Re: **Clearman's Village; Regional Planning Commission Hearing Date:  
September 28, 2005; Conditional Use Permit and Zone Change No.  
03-147-(5)**

To:	Dwight Steinert Planning Associates, Inc.	Date:	September 12, 2005
From:	David S. Shender, P.E. Linscott, Law & Greenspan, Engineers	LLG Ref:	1-033347-1
Subject:	Kohl's Commercial Development Project Review of Jones Engineers Letter

Draft Traffic Impact Report Comments  
Re: Clearman's Village Commercial Site

EXISTING AND FUTURE AVERAGE DELAY  
AT ROSEMEAD/HUNTINGTON INTERSECTION  
PM PEAK HOUR

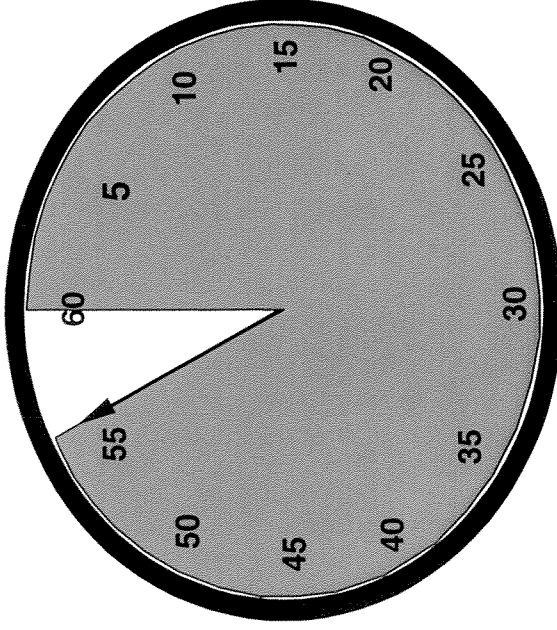
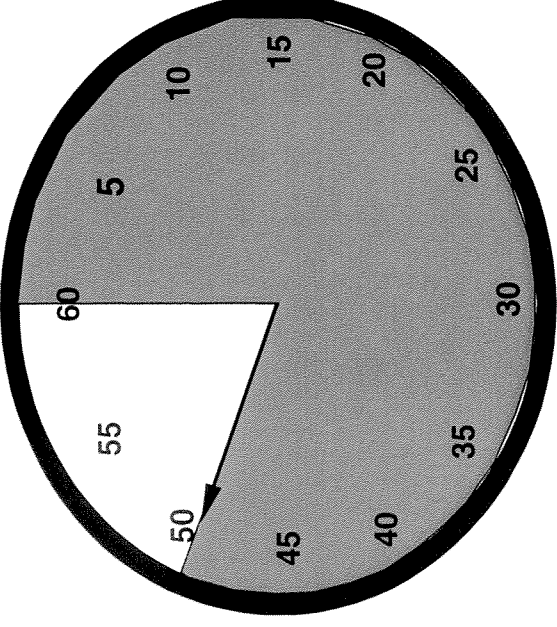
At Tab 5 is an comparison of the existing and future delay times at the intersection of Rosemead and Huntington at the PM peak hour. This exhibit illustrates how the mitigation measures incorporated into project, such as the two left-turn lanes, will actually improve existing traffic conditions. Indeed, it shows how the project will reduce existing motorist delays by 13 percent.

COMPARISON OF REDEVELOPMENT OPTIONS  
FOR CLEARMAN'S VILLAGE

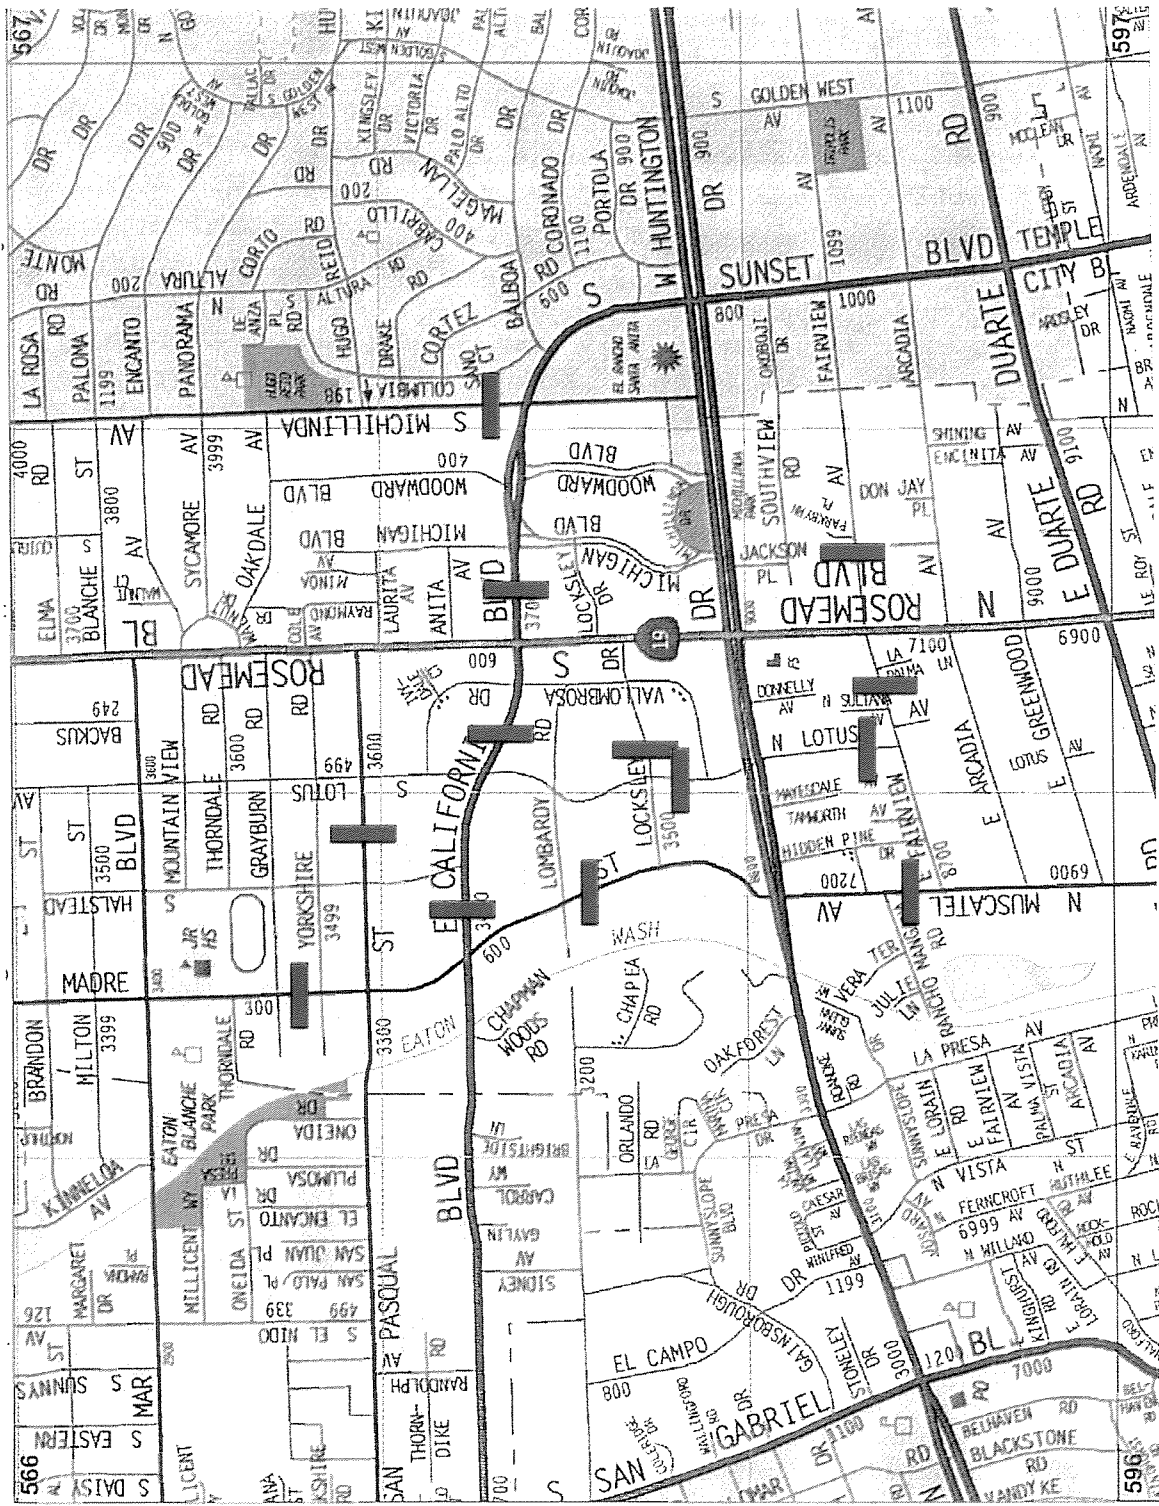
At Tab 6 is a comparison of the traffic volumes generated by Kohl's versus other types of uses which could be built on the site, such as a supermarket or a discount store. The comparison shows that Kohl's generates significantly less traffic than those other uses, especially during the PM peak hour.
